ADDENDUM NO. 03 5 April 2010

Project: **A NEW TRANSPORTATION FACILITY**
Dickinson Independent School District

Project No.: **0806**

4. This Addendum consists of two (2) 8-1/2x11 written pages, and two (2) 30x42 attached full size sheets; **S1.1** and **S1.2**; as prepared by Concept Engineers. Total pages: 4 pages.

4 DETAIL 3/4"=1'-0"

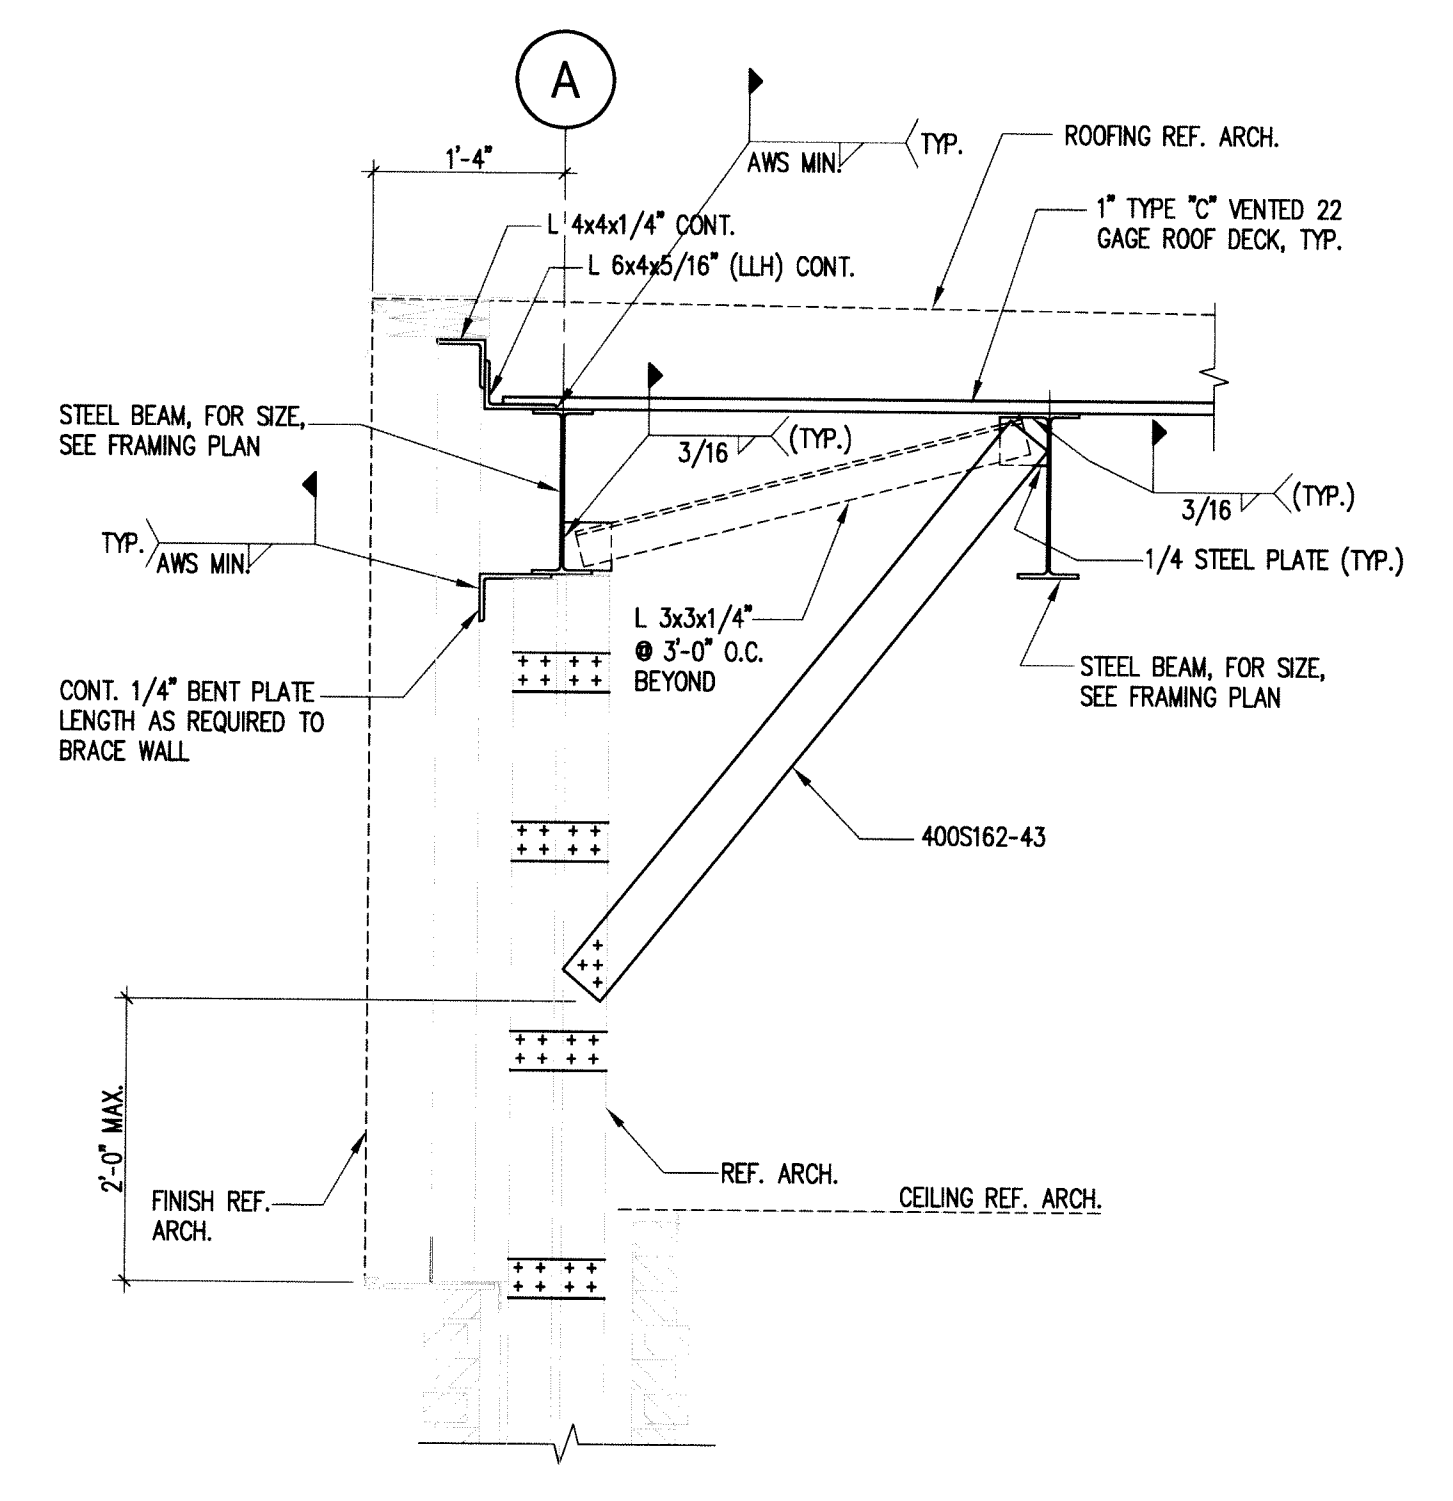
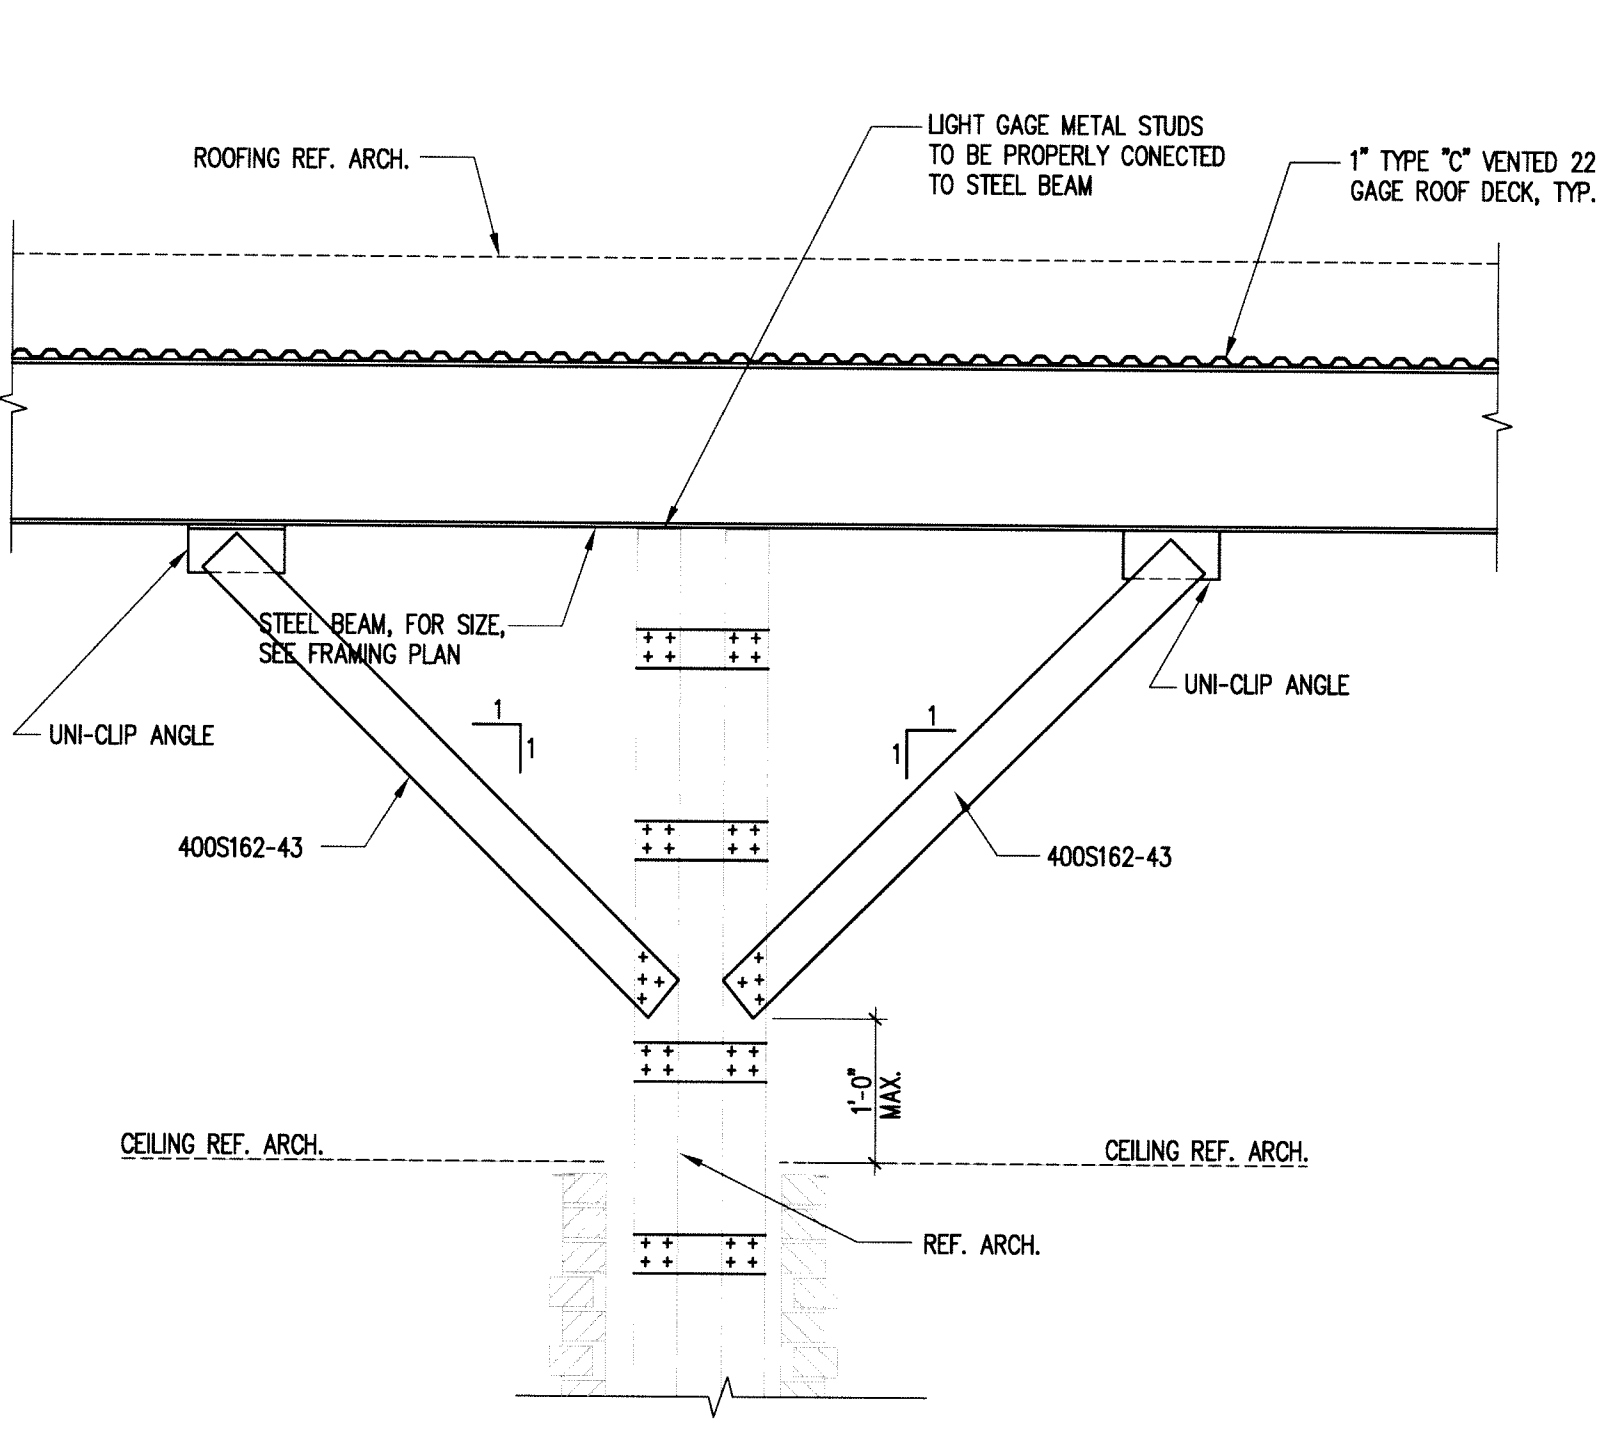
8. Sheet S1.1 Foundation Plan & Details Child Nutrition Building: Add foundation plan and details of entrance area of Child Nutrition Building. Also add the foundation plan and details to support fuel tank at fuel dispensing area.
9. Sheet S1.2 Roof Plan and Details Child Nutrition Building: Add roof framing plan and details of entrance area of Child Nutrition Building.
